# Product Change Notification

**Change Notification #:** 119788-00

**Change Title:** Intel® RealSense™ Depth Camera D457,  
PCN 119788-00, Product Material,  
FAKRA connector change from C-code to Z-code

**Date of Publication:** January 17, 2024

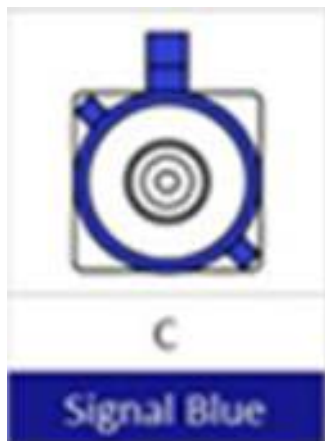
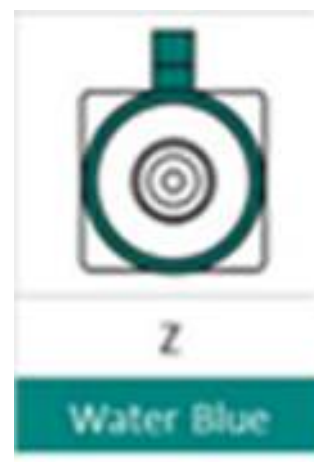
The FAKRA connector in the Intel® RealSense™ Depth Camera D457 is changed from C-code to Z-code

### Current FAKRA Connector: C-Code

### New FAKRA Connector: Z-Code

No impact is expected to customers, as Z-code connector is compatible with all FAKRA connectors. The camera's rear house design will be modified to accommodate the new connector, but the camera's dimensions remain the same.
